Phi Mu comments on proposed  
157 E. Rosemary development

Chapel Hill Town Council  
November 29, 2023

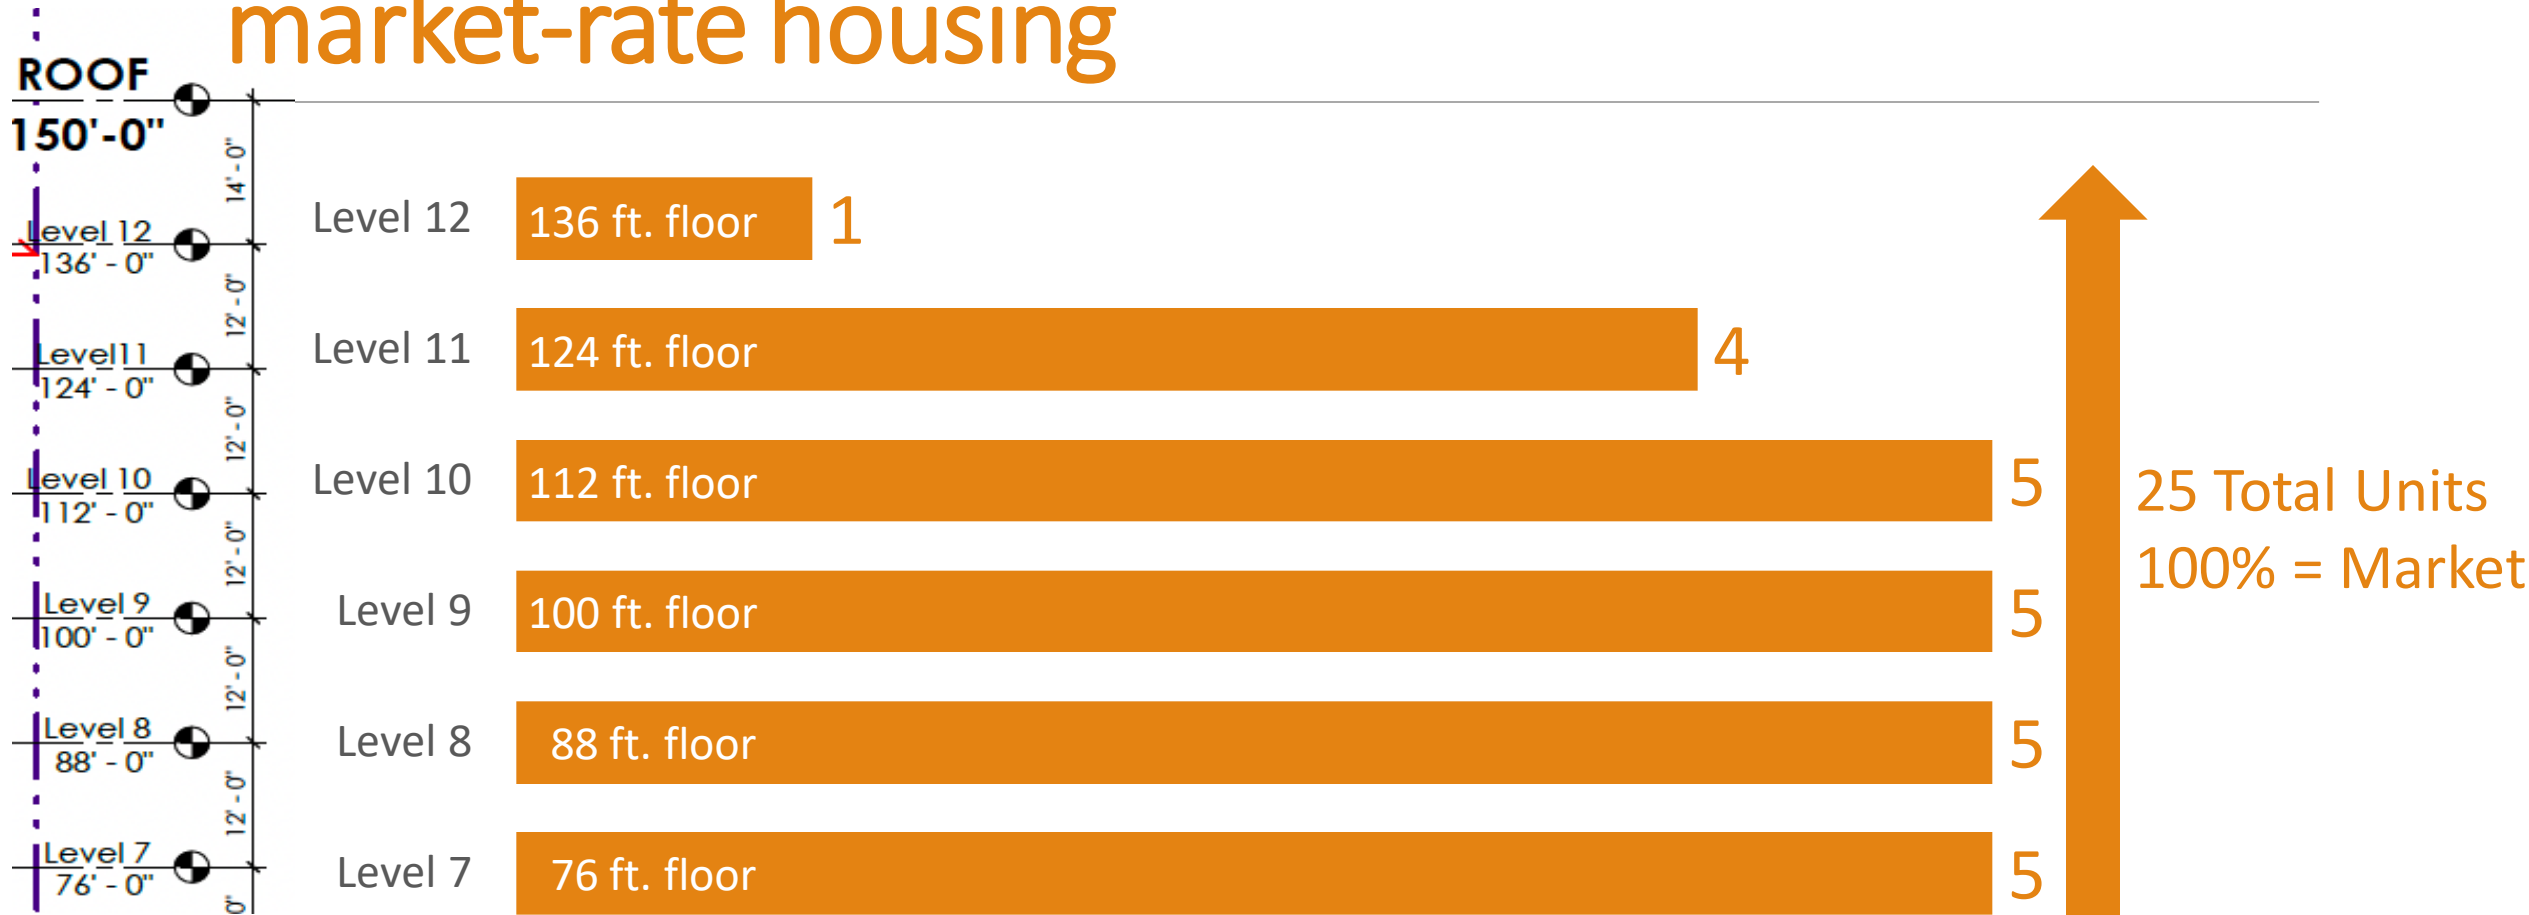
# 100% of the additional height requested is market-rate housing

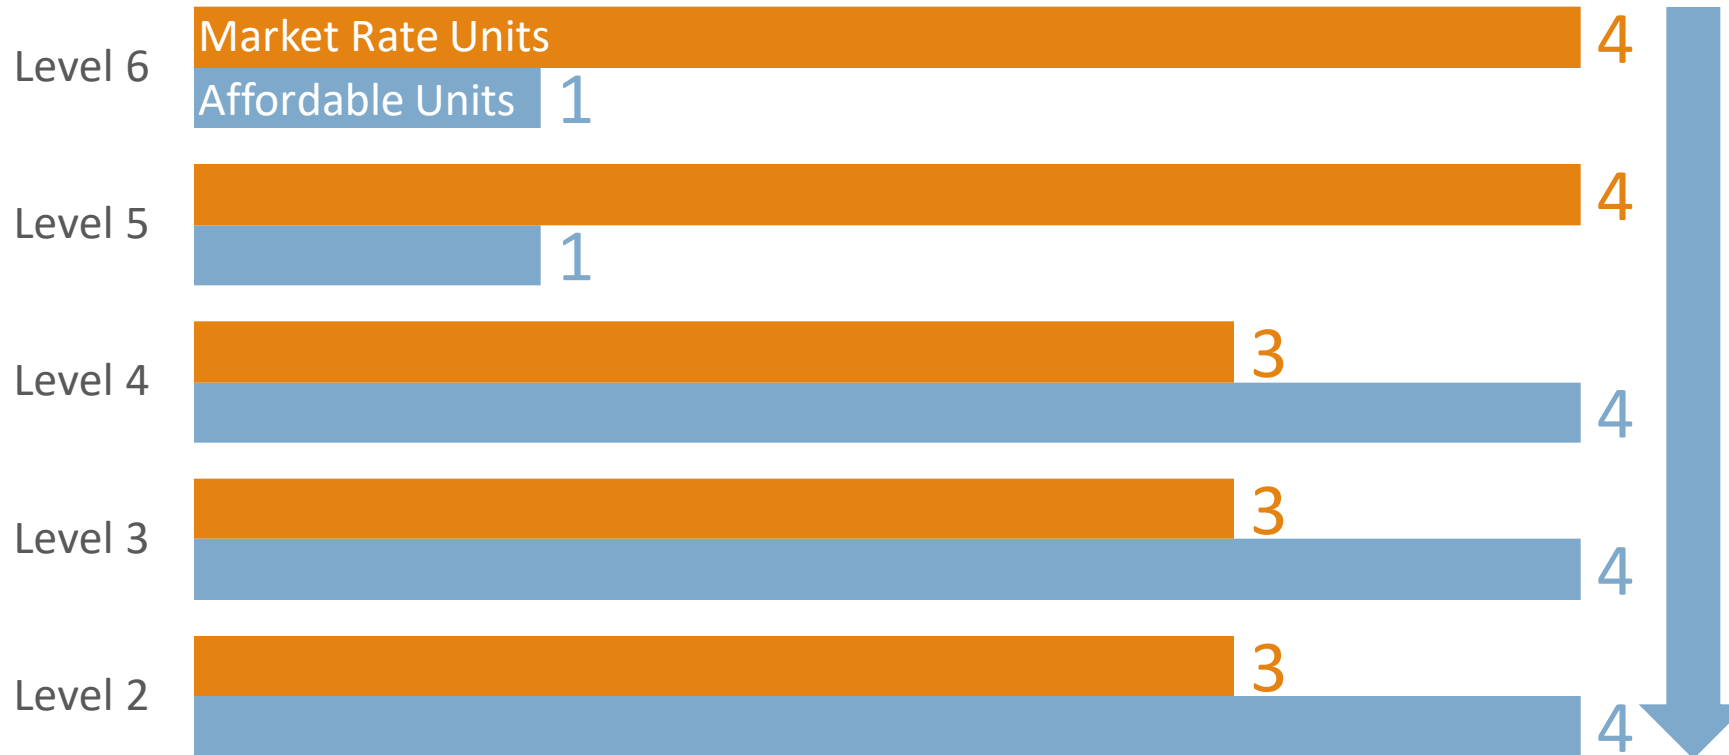
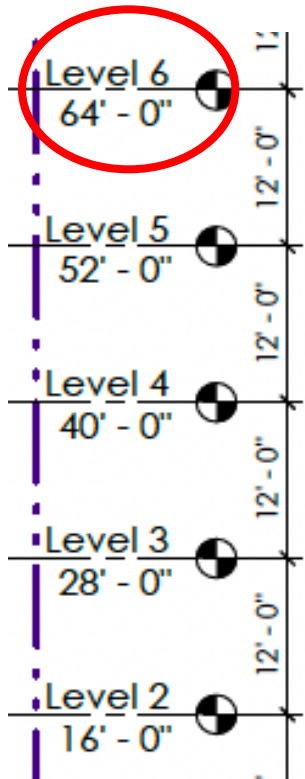
# The 60' core contemplated in R-CP-CZD is exceeded at Level 6 of this design

SIGHTLINE DIAGRAM

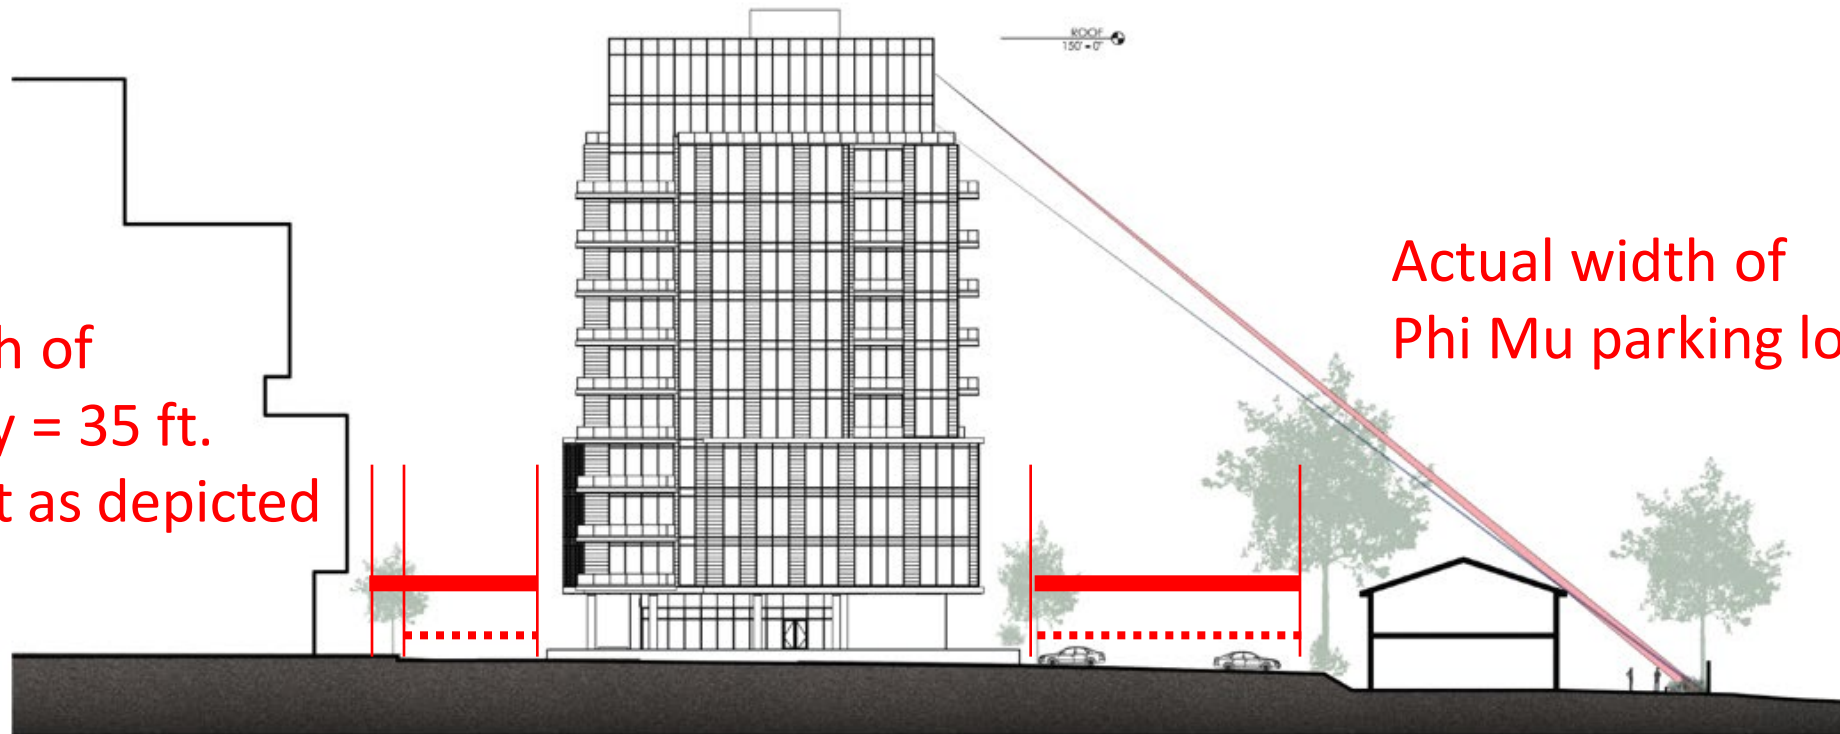
# This diagram provided by the developer is not to scale

Actual width of  
E. Rosemary = 35 ft.  
vs. 30.5 feet as depicted

Actual width of  
Phi Mu parking lot = 55 ft.

Without a 3-D Model built to scale that includes differing lot elevations, it's difficult, if not impossible, to visualize how this development would tower over our home and adjacent businesses on E.

SIGHTLINE DIAGRAM

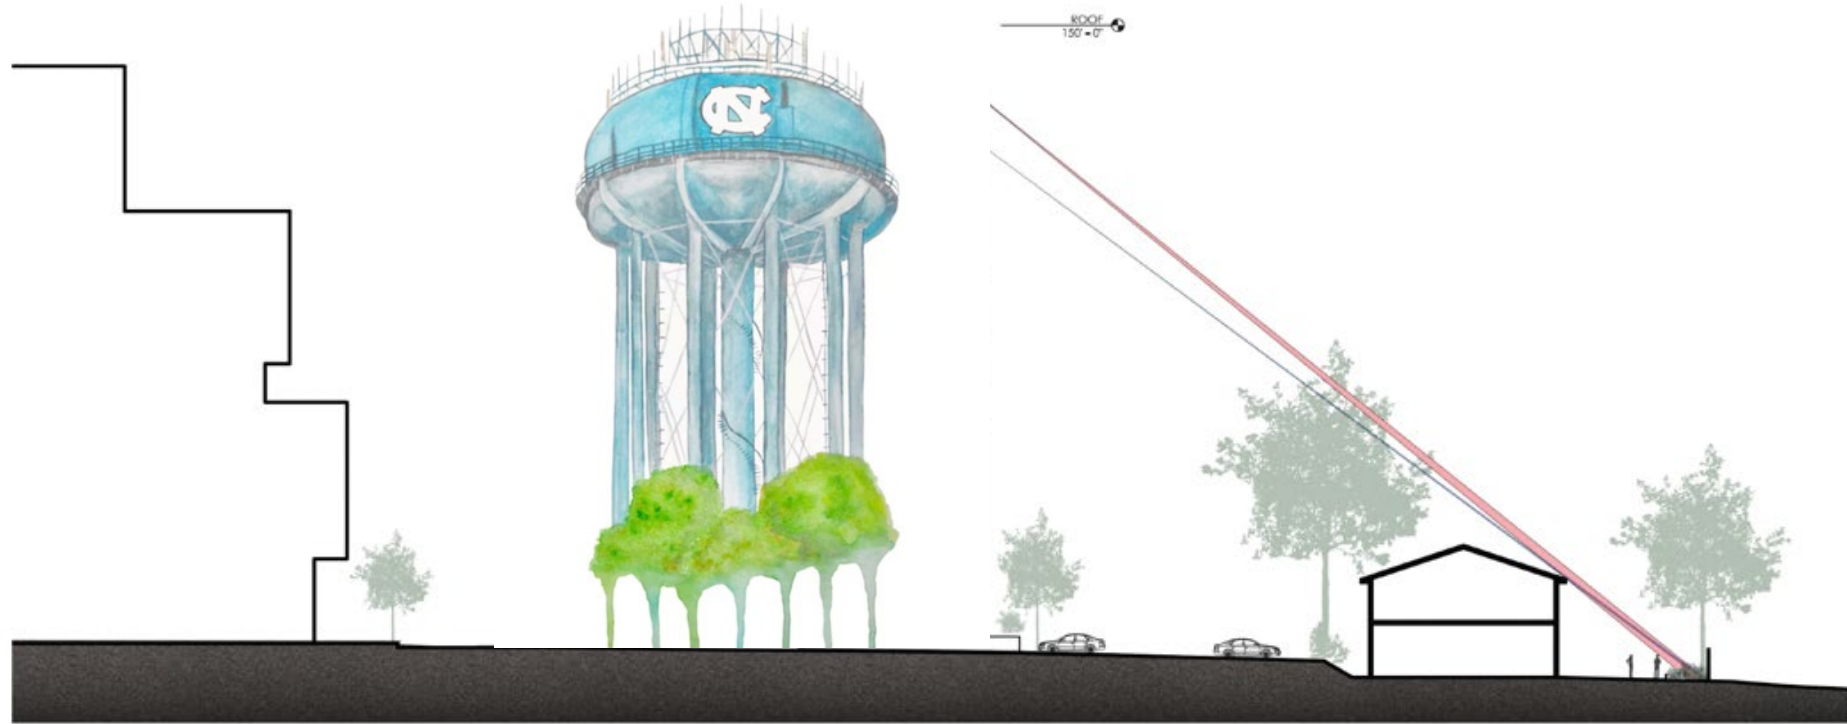
# The proposed structure is 7 feet taller than the Manning Drive UNC Water Tower
